Application for Licence

Licence Number	L3014/2025/1
Applicant	Image Resources NL
ACN	063 977 579
Application number	APP-0029030
Premises	Atlas Project Munbinea Road Legal description - Part of mining tenement M 70/1305 As defined by the premises maps in Schedule 1
Date of report	06/11/2025
Decision	Licence granted

Figure 3: Dust #1 shows where the PM₁₀ dust monitor was installed during time limited operations

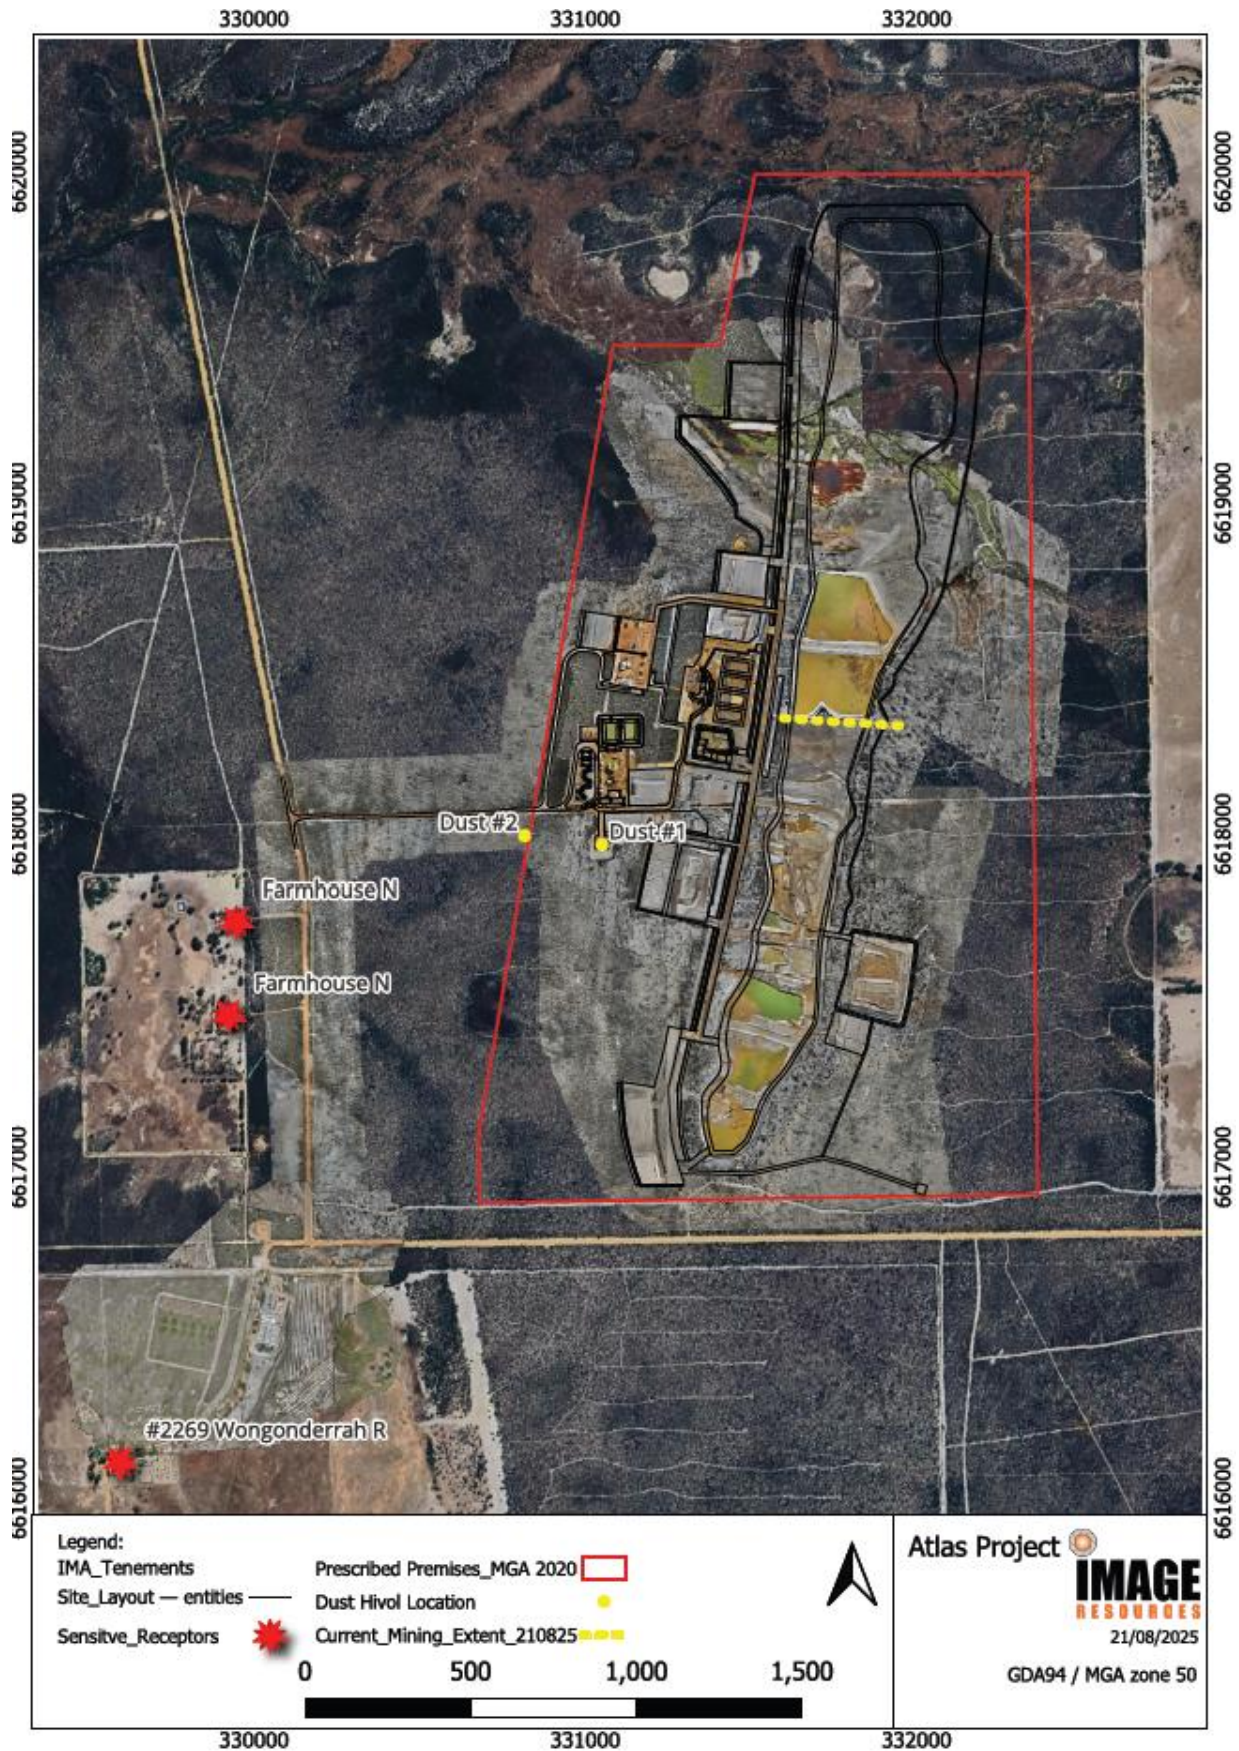
The results of the dust monitoring campaign can be seen in Figure 4, below. It shows 4 exceedances of the NEPM standard out of the 25 samples taken during this time. Dust levels are expected to be significantly lower at the receptors, indicating that the existing dust controls are likely to be sufficient to manage dust impacts to receptors.

Continued October to May dust monitoring will be required on the licence, but the applicant will need to relocate the dust monitor to a location further from the mining and processing activities (and any other dust generating locations, such as near a road), and as close to the receptors as possible. This will provide a better understanding of potential dust impacts from the project on receptors.

Figure 5: Location of groundwater monitoring bores I01 to I08.

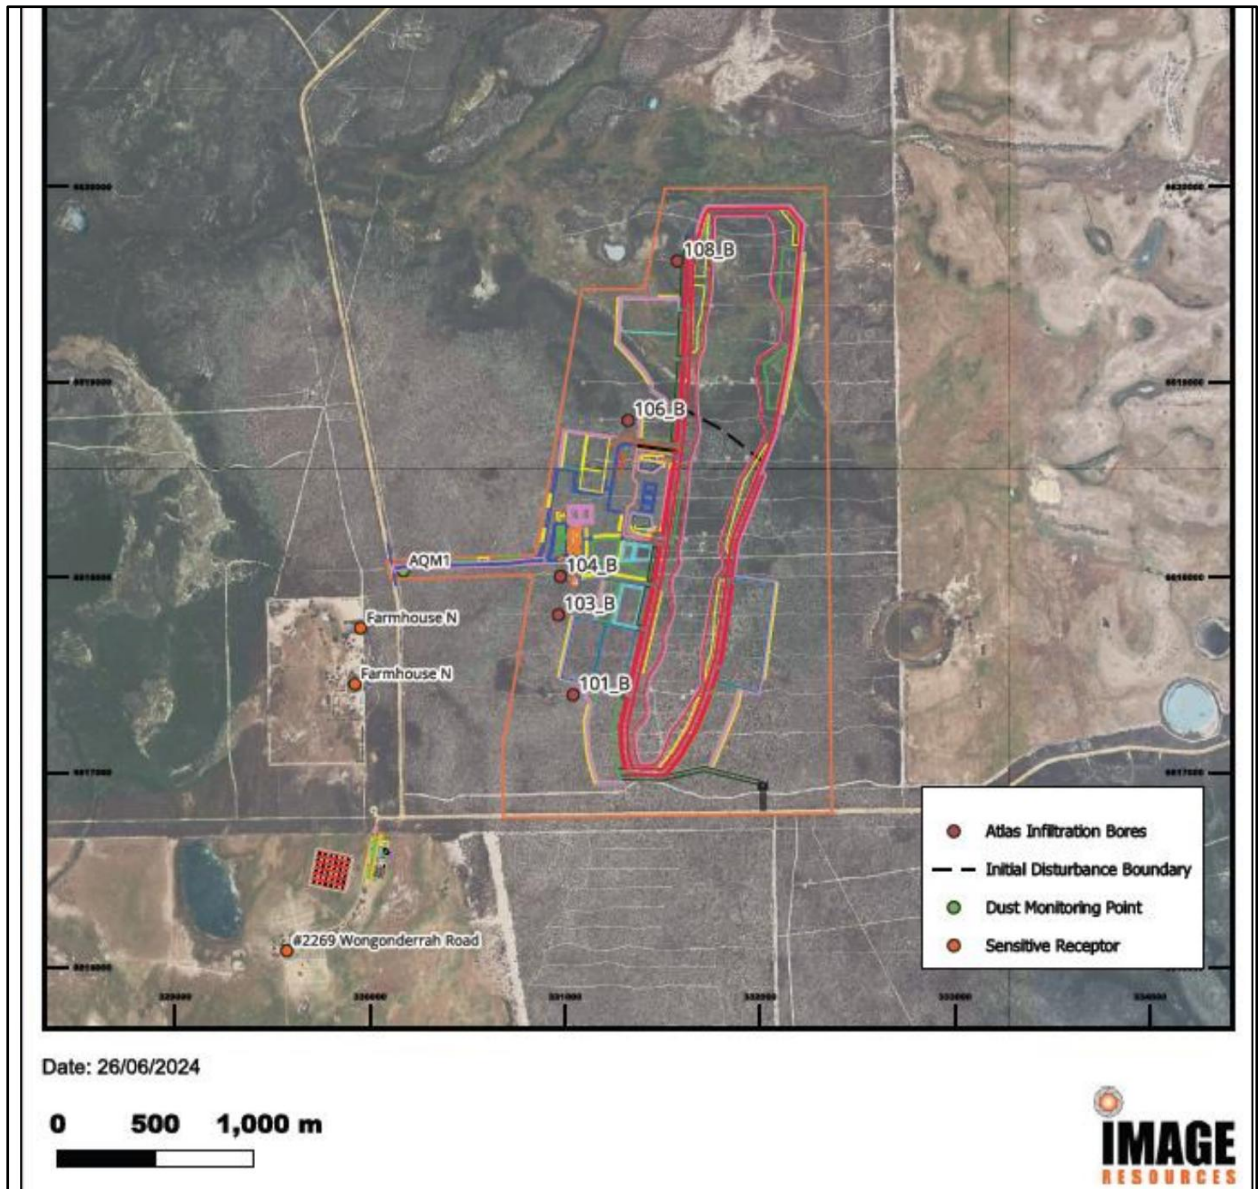
Groundwater bores to the west of the open pit area were drilled in April 2024 and have been monitored for standing water level and selected water quality parameters since October 2024 (see Figure 5, below). The standing water levels have been consistent over this time, between 2.8 metres below ground level (mbgl) and 7 mbgl. The applicant has revealed that dewatering of the open pit has not yet been required due to a lack of inflows into the pit, even though modelling suggested that mining should be occurring through the water table at this point.

Figure 6: pH of groundwater bores at the Atlas Project between October 2024 and April 2025

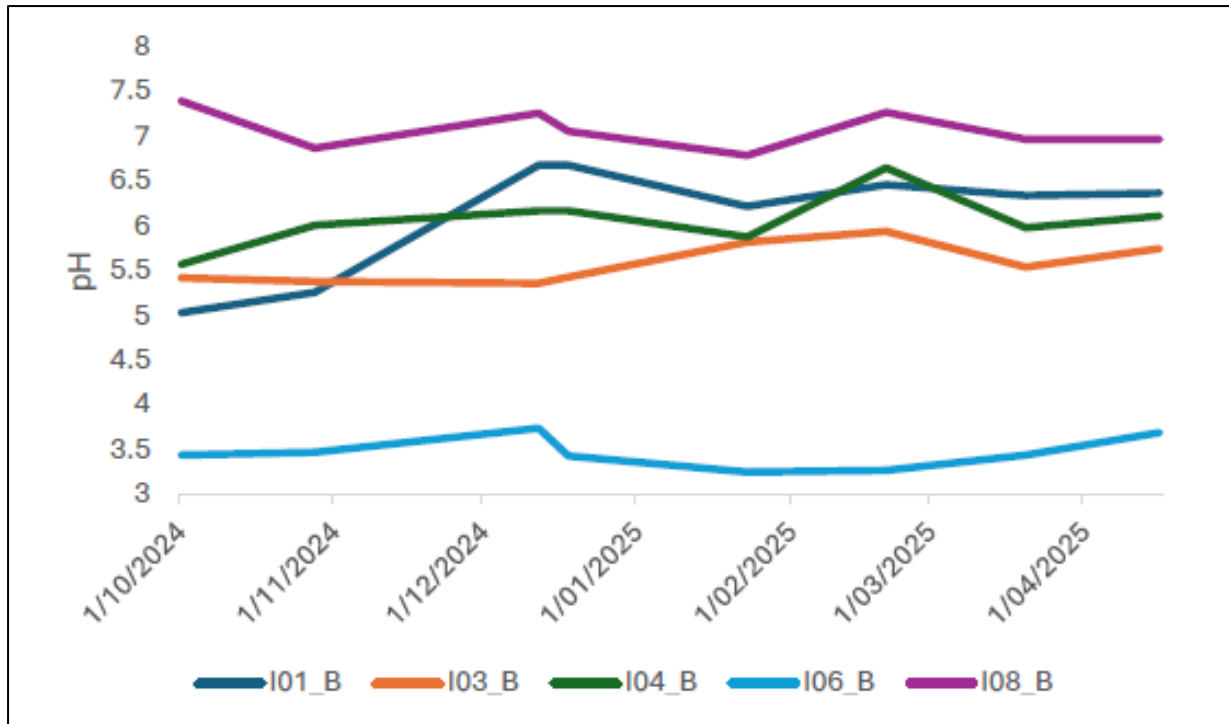
It is noted that the pH of the bores is generally between pH 5 and 7.4, with the exception of I06 which has a pH of about 3.5 (see Figure 6, below). This bore also has elevated sulfate, high levels of dissolved aluminium (40-60mg/L), a total titratable acidity of 500 to 735 mg/L and no detectable alkalinity, suggesting that this bore is being strongly impacted by acidification. Given that mining of the southern area only commenced in late 2024 and given the trend has neither increased or decreased during the monitoring period, this suggests that these results are a factor of the specific soils at this location and is unlikely to be an indication of groundwater deterioration from mining activities over the past several months.

It is similarly noted that bore I03 has elevated sulfate levels and has a total dissolved aluminium over 1mg/L, which are both early indicators of acidification from acid sulfate soils. It will be critical that the applicant tightly manage impacts from acidification from the project to prevent further groundwater quality deterioration, given these early indications.
